MCPPB
06.27.02
Item # 5

MEMORANDUM

REVIEW TYPE: Site Plan Review
APPLYING FOR: Approval of 42 Townhouses and 1 Single Family Detached
PROJECT NAME: Grandview Townhomes
CASE #: 8-02034
REVIEW BASIS: Site Plan Review is required in the TS-R Zone
Section 59-C-8.45 of the Montgomery County Zoning Ordinance

SITE PLAN
GRANDVIEW TOWNHOMES
 LOTS 21 & 22 REFEED #14
 AND LOT 27 & PARCELS A, BLOCK 24

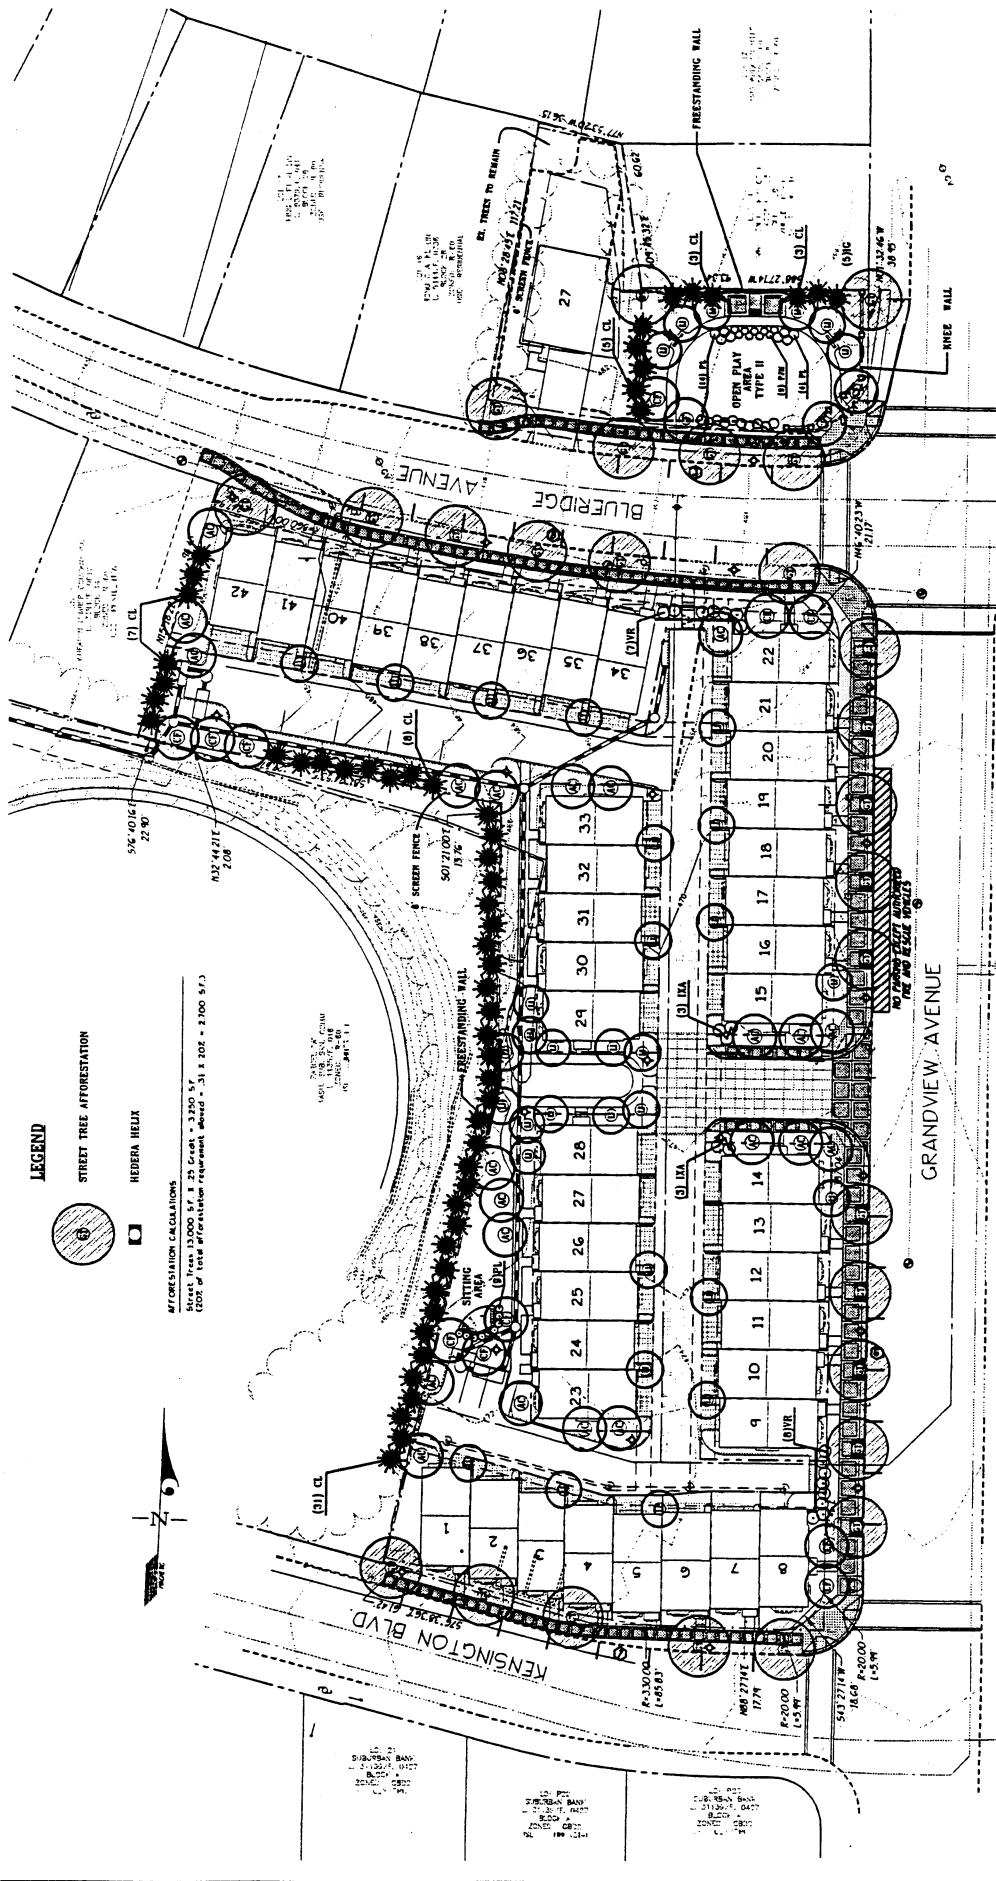
- a. Site Plan Signature Set shall show all easement lines, LODs, PUEs, ROWs, pavement markings, traffic signals, curbs, setbacks, slopes of sidewalks, riser numbers, on-street parking, and all grading;
- b. Provide details of furnishings and fixtures, railings, gates, pavers, walls and garage doors at Signature Set.
- c. Provide solid brick facing wall(at least 10 in width) for the rear of units 28 and 29 (as used for units 8 and 9) to create attractive façade for the two unit rears visible to pedestrians from Grandview Avenue.
- d. Provide colored concrete parking pads at garage and driveway entrances.

The remaining outstanding issue concerns reducing the visibility of the rears (garage, utilities, and trash receptacles) of two townhouse units from the view of pedestrians on the public sidewalk. Staff recommends that the end unit type proposed for units 8, 9, and 22 be used for units 28 and 29. The use of the one-car garage type will allow the portion of the unit rear visible to the street to be an attractive brick surface that frames the center courtyard.

unit rear facades from the public sidewalk on Grandview Avenue. The tightness of the site and the maximum unit count in these strings of houses create two houses that expose the rear façade, normally private zone of the house (garage doors, heat pump, AC, and trash) to the street. Staff recommends that a one-car garage type be used for these two units (proposed by the applicant for units #8, #9 because of tight garage entry): the use of this unit type will allow the construction of an attractive brick wall in place of one garage space--to wrap the building corners that adjoin the central courtyard and to mask the garage doors, utility connections, and trash receptacles visible from Grandview Avenue—providing a permanent, sustainable architectural feature that will enhance the project's interior and comply with the goals and desired character of the Wheaton CBD streetscape plan.

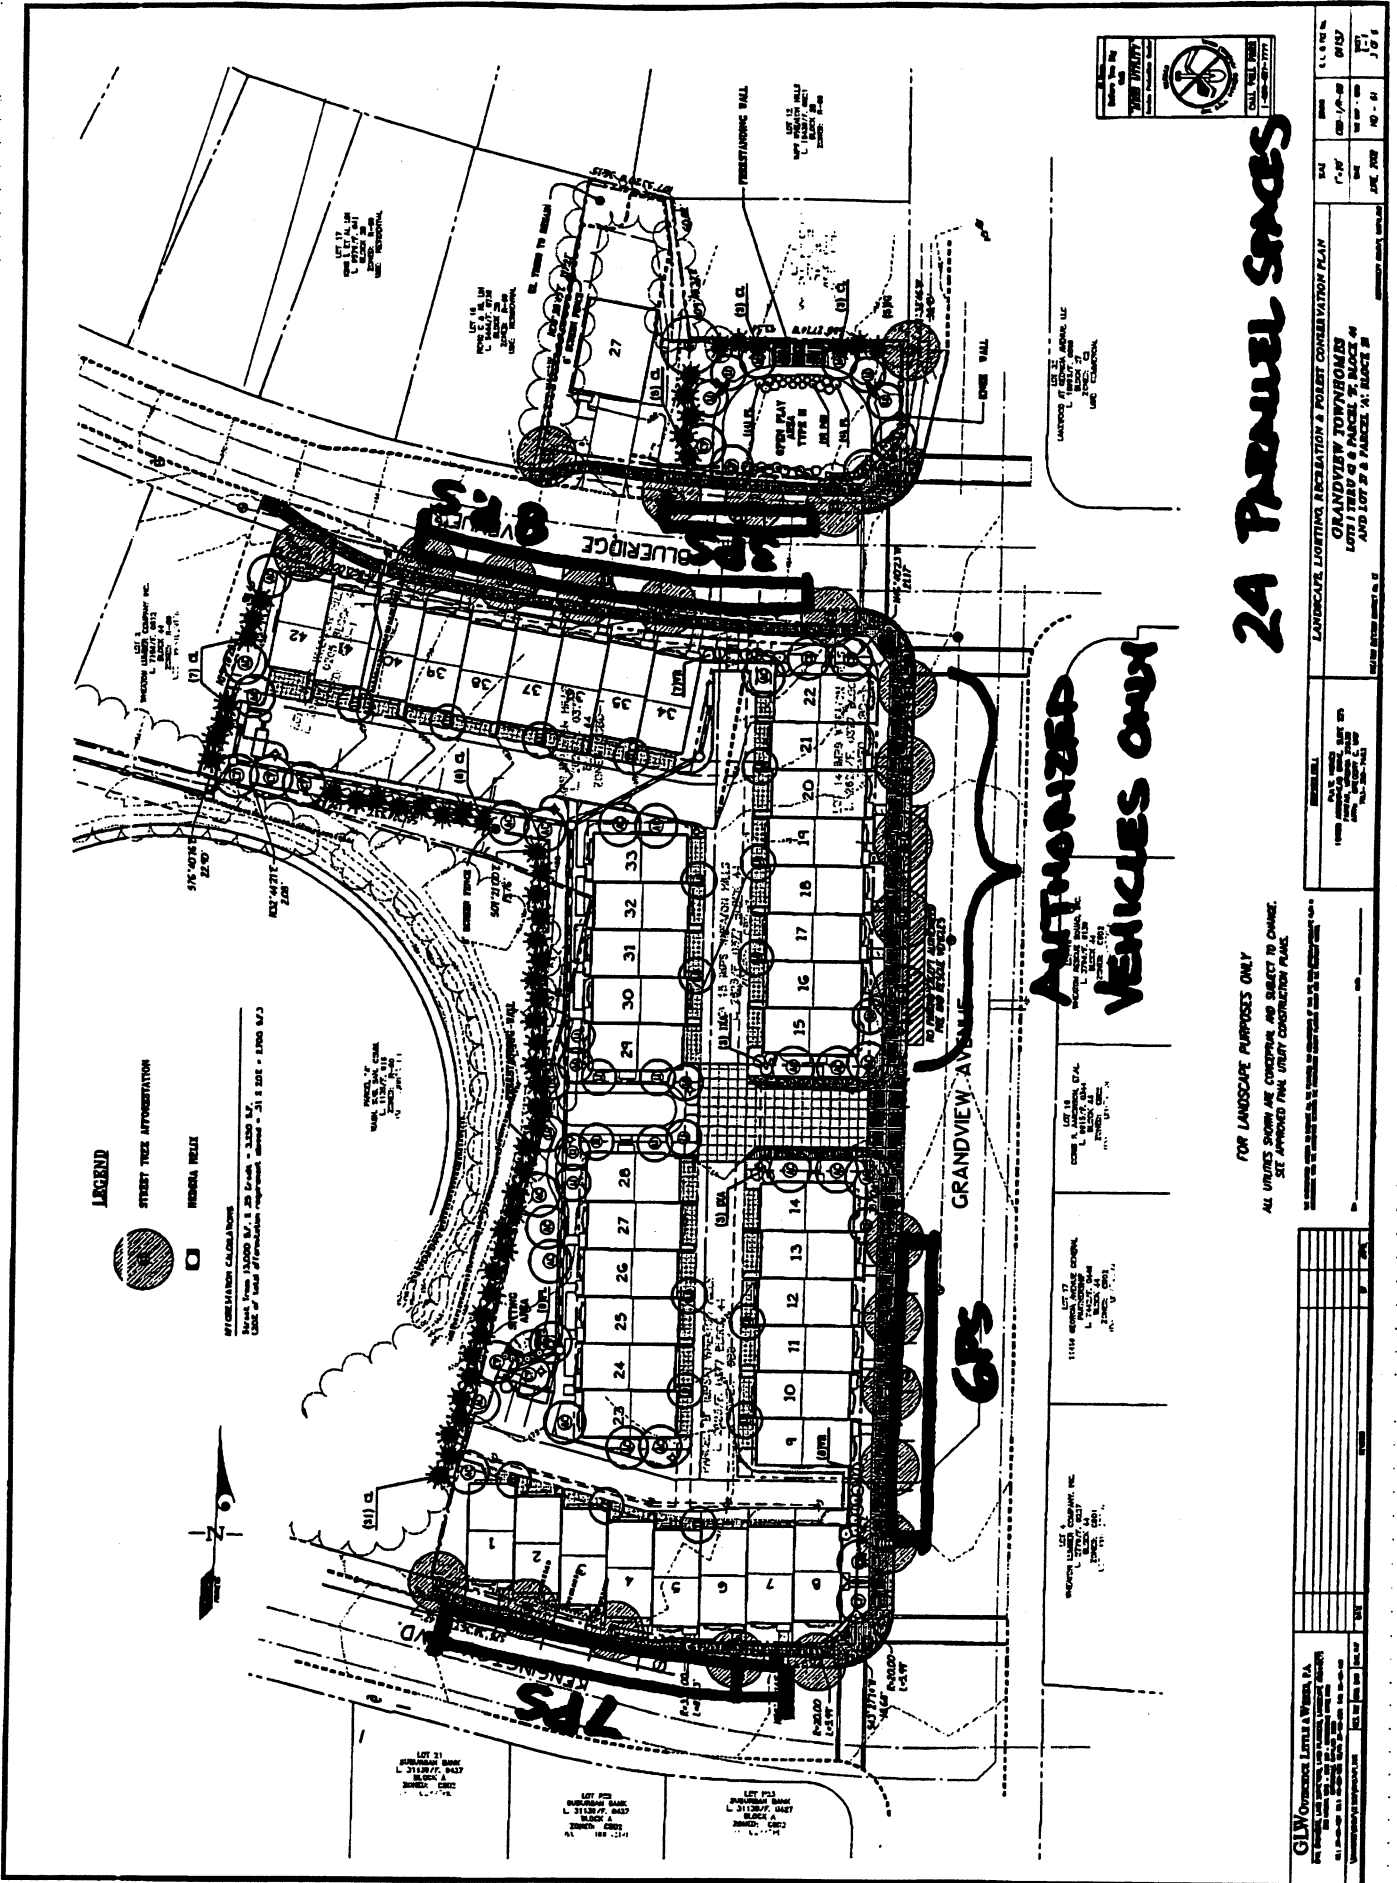
- e. Applicant shall provide area streetscape drawing showing subject site and extended area of Grandview Avenue; drawing shall demonstrate compliance with the Wheaton CBD Streetscape Guidelines Area. Final streetscape drawings, including tree spacing, lighting, paving, etc. are subject to subject to staff, DHCA, DPS and DPWT review and approval.

- f. Provide with the landscape plan a detail for the tree box soil panel: the detail shall demonstrate that no less than six feet of soil depth shall be provided where trees are proposed and that ensuring that the planting areas will be adequately drained.

- g. Provide drawings of the entrance court and open play area (park) at 1" = 10'.
- h. Provide details for the freestanding walls; provide new fence for the north side of the park and incorporate freestanding brick wall with the fence.

- i. Provide additional shrub plantings at wall that close the internal driveways.
- j. Shift placement of ornamental trees at garage islands to the west island of units 9, 11 and 13; provide additional ornamental tree for south side of unit 34.

- k. Provide lighting details and specifications, including lamp type, wattage, house shields, and mounted height; include as part of landscape drawing.
- l. Provide standard type light distribution plan showing lighting levels in accordance with the Illuminating Engineering Society of North America, *IESNA Recommended Practice* for public recreation space and sidewalks.
